# 334 PONCE DE LEON AVENUE LAKE CHEROKEE HISTORIC DISTRICT

## PROJECT OVERVIEW

This is a request for a Major Certificate of Appropriateness to demolish a non-contributing residence and to build a new Single Family Residence. The current Lots 8 and 9 would be re-platted to give additional square footage to 608 Lake and minimize the size of 334 Ponce DeLeon lot.

334 PONCE DE LEON PL- FRONT ELEVATION  
(OPT A-ORG.)

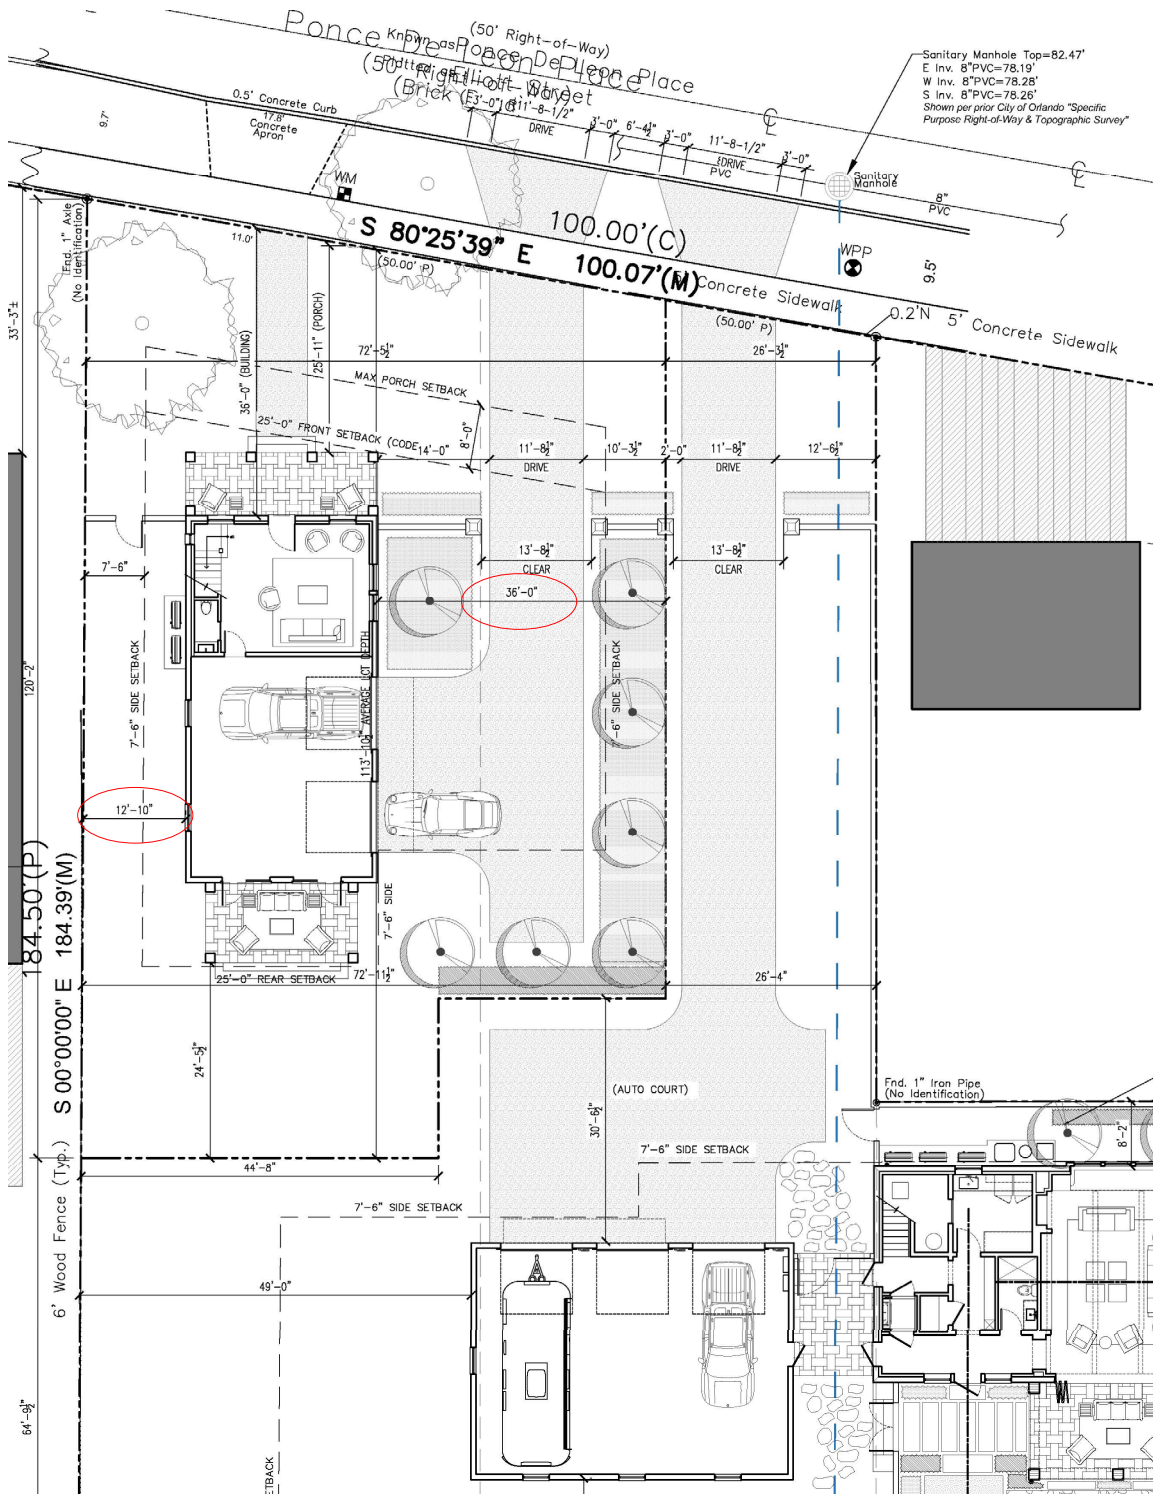
Option A has no change to the architecture or placement of the house on the lot. Walls have been added parallel to the front face. This elevation leaves off the additional 30 ft to the left that is vacated by the driveway to 608 Lake Ave. Additionally, the applicant places the garage for 608 Lake in that void but the structure is over 120 ft back from the sidewalk.

# OPTION B FRONT ELEVATION

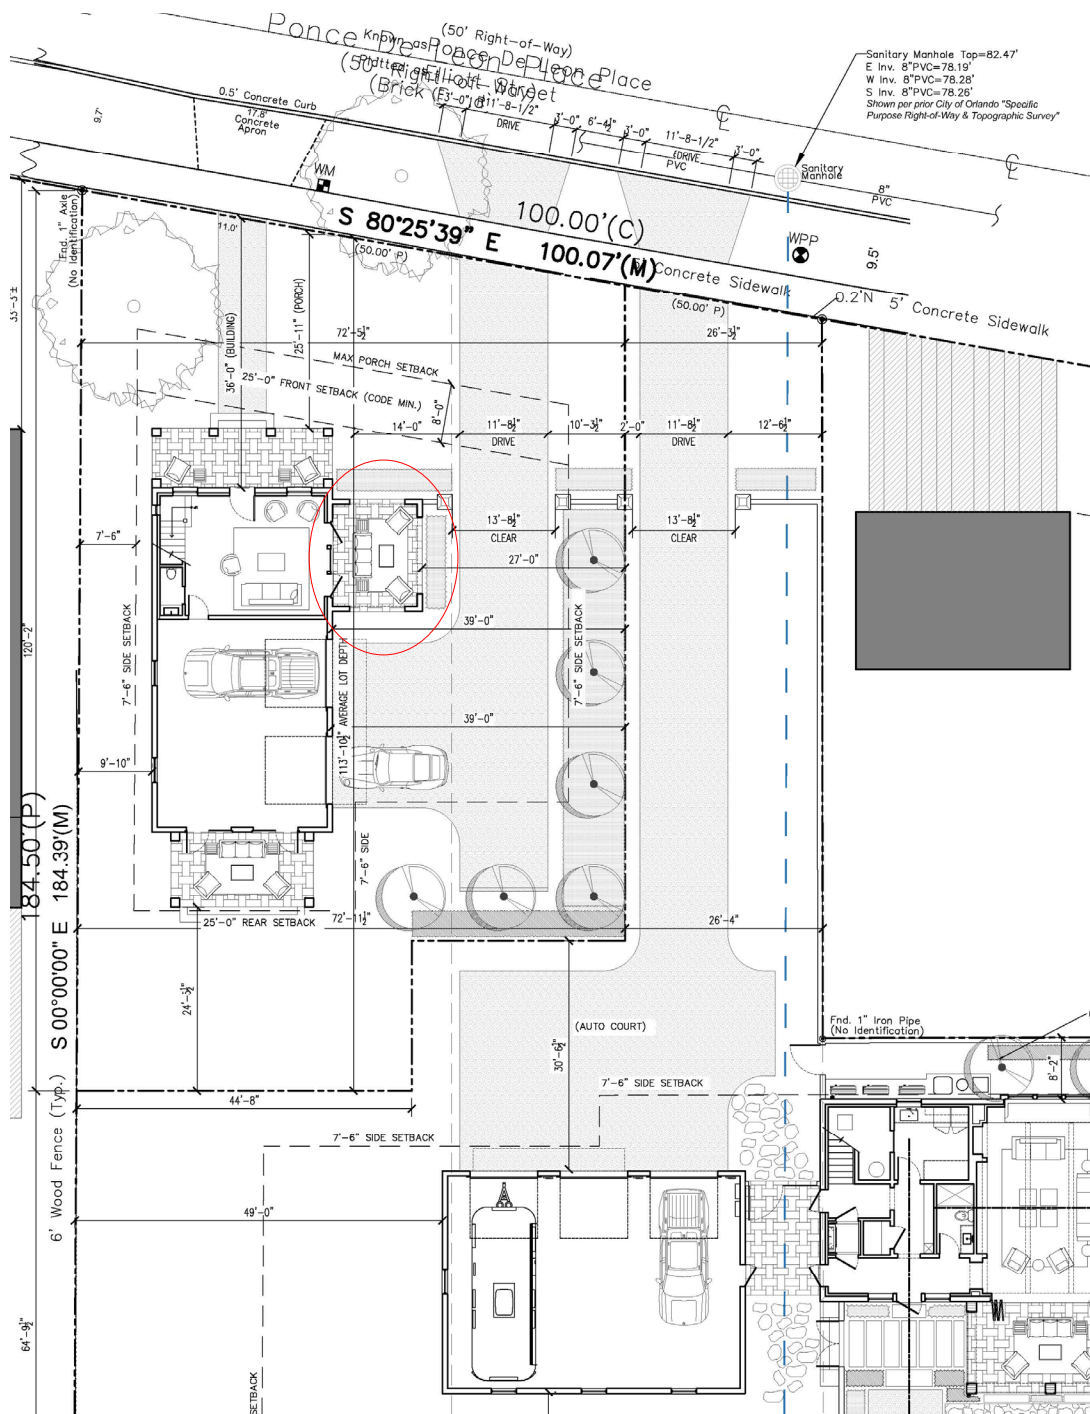
Option B has no change to the architecture or placement of the house on the lot. Walls have been added parallel to the front face. This elevation leaves off the additional 30 ft to the left that is vacated by the driveway to 608 Lake Ave. Additionally, the applicant places the garage for 608 Lake in that void but that structure is over 120 ft back from the sidewalk.

# SETBACK STUDY

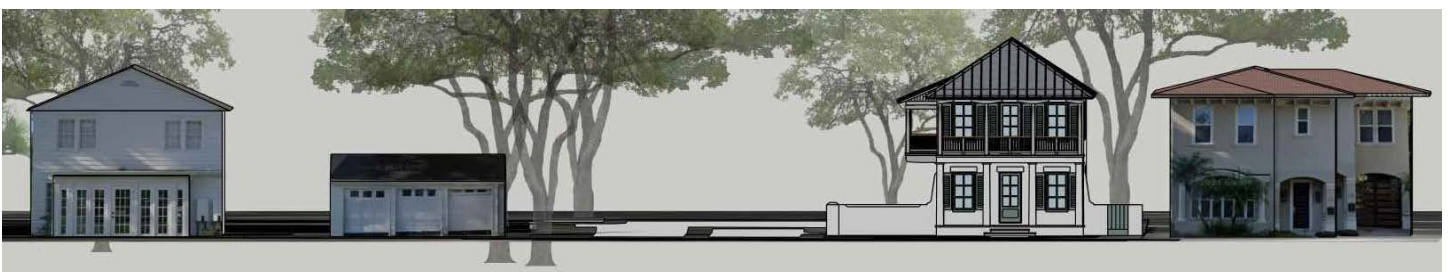
There are three contributing structures with varying setbacks increasing towards Lake Avenue. The average setback for the block face is 28 ft. However, the setbacks are increasing as the lots move towards Lake Ave and the adjacent house at 332 Ponce DeLeon, constructed in 2005 was set at 31 ft setback. Staff is recommending the new house at 334 Ponce DeLeon be setback 31 ft instead of 36 ft proposed. As with past board discussions, staff is concerned that the 2 story porch will read as the front façade given its mass. The board could consider a 1 story porch or separate the roof structure of the upper porch to lighten the mass of the continuous roof.

4. The house shall be moved north 5 ft for a front setback of 31 ft to match the adjacent structure to the west.
5. The driveway shall be moved to the west side of the house.

334 PONCE DE LEON PL- SIDE ELEVATION

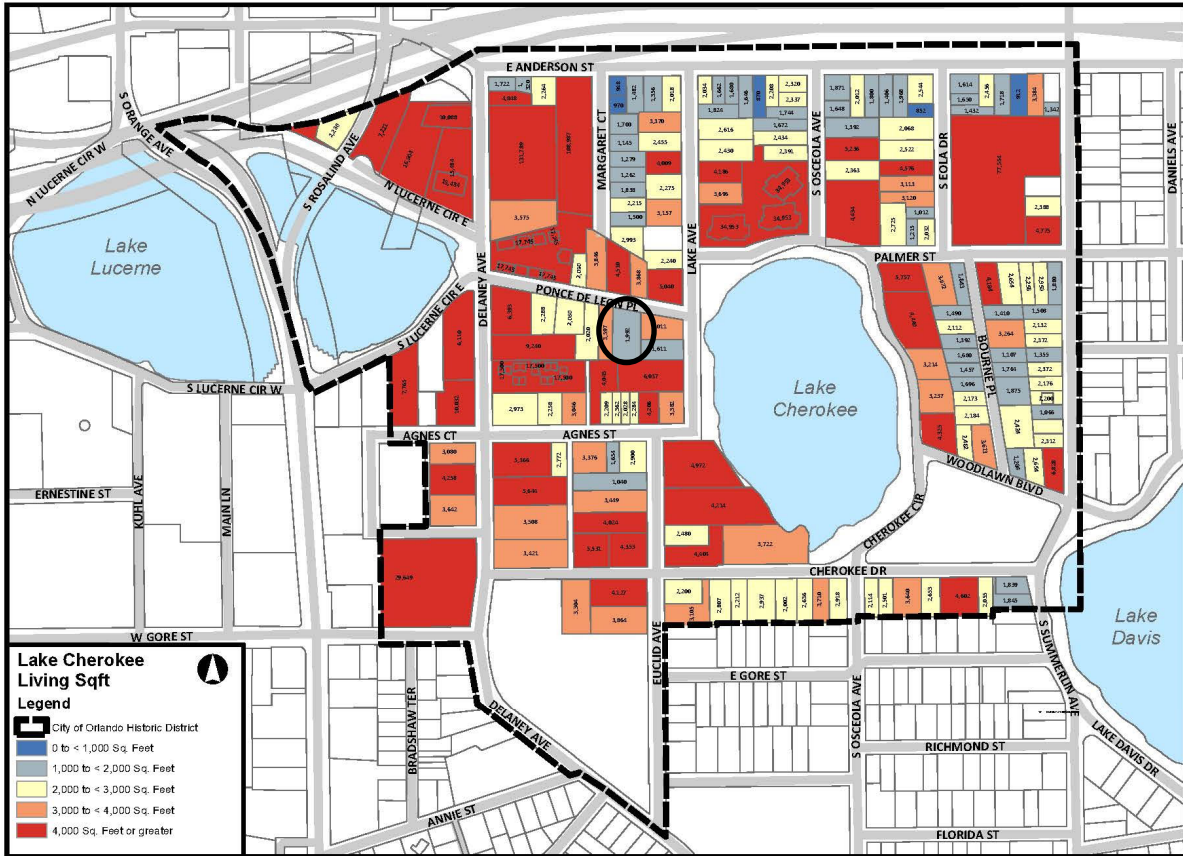
**The house is narrow as proposed in option A but better with the screened room in Option C. Staff is recommending the house be placed 31 ft from the front lot line to match the adjacent structure to the west. To balance the projecting 2 story porch either separate the porch roof from the main roof or reduce the porch to 1 story.**
